# Technical Service Bulletin

## 20 MIL on (DTC P045600 - EVAP system leak detected NVLD (very small leak))

20 15 48 2035073/10 October 15, 2015. Supersedes Technical Service Bulletin Group 20 number 15-46 dated May 15, 2015 for reasons listed below.

*Figure 6. Correctly-installed sensor and grommet.*

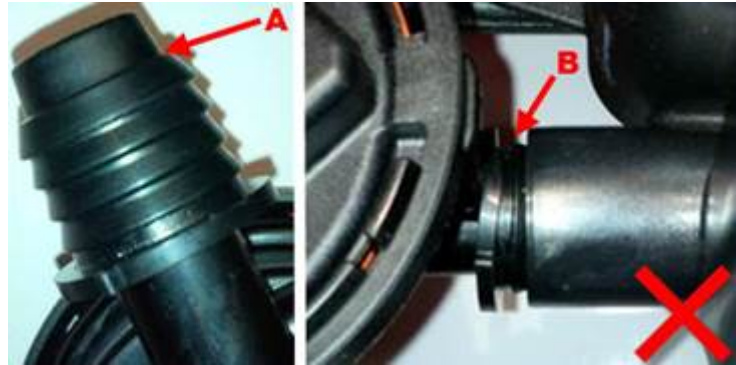
- When the sensor and grommet have been correctly installed, the grommet and canister will be flush (Figure 6). At this point, the vinyl tape can be removed (or it can be left in place).
